Planning Commission Staff Report

Subject: Rezoning Issues Report

Meeting Date: September 24, 2007

Petition P.Z. 41-2007 Chesterfield Blue Valley

7-5/08/07 REVISED PER CITY COMMENTS
1-7/23/07 REVISED PER CITY COMMENTS
CHESTERFIELD BLUE VALLEY, L.L.C.
PRELIMINARY DEVELOPMENT PLAN

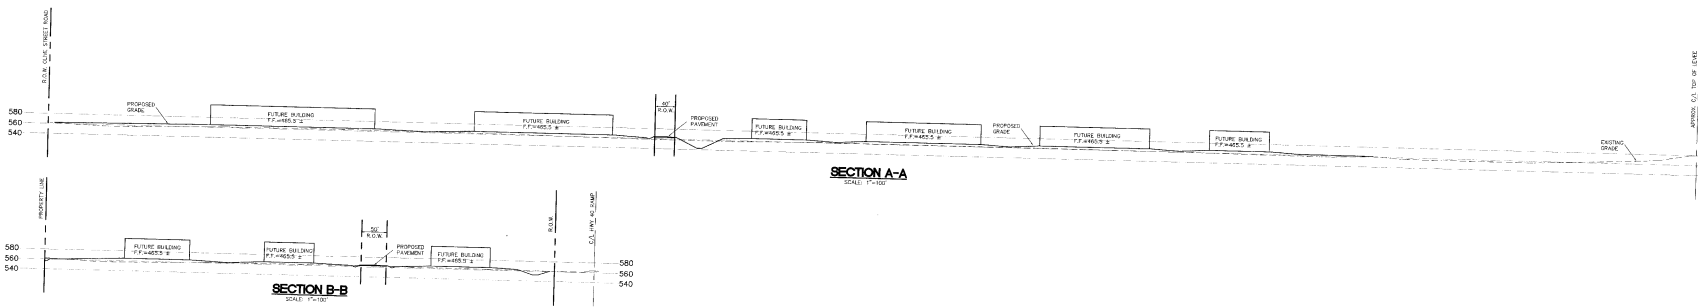
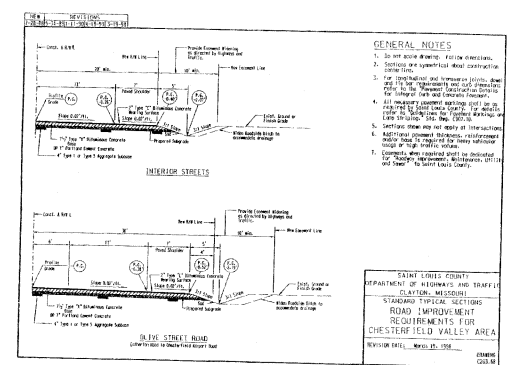
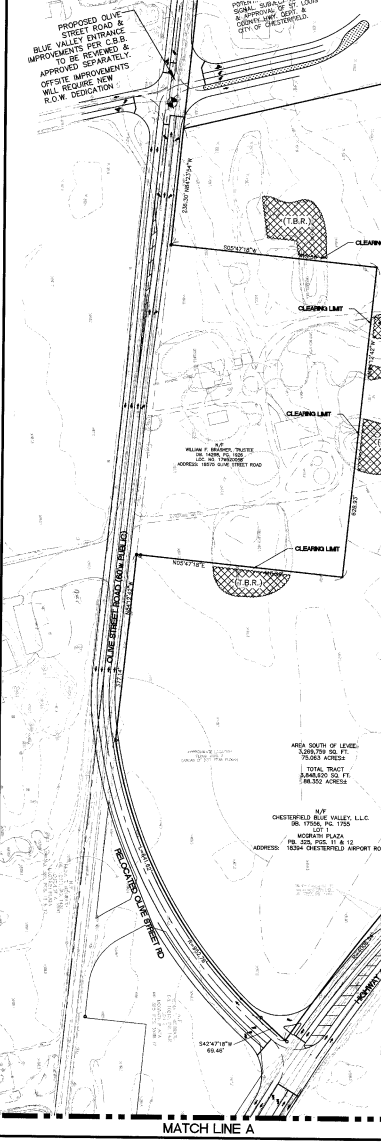
4. At the Site Development Plan stage of development, the location of the drainage ditch in relation to the cross access road proposed to connect this development to the Blue Valley I development.

The location of the drainage ditch and the cross access road are shown on the plan. Both elements' locations were determined by coordinating connection points exactly to those approved elements in Blue Valley I development plan.
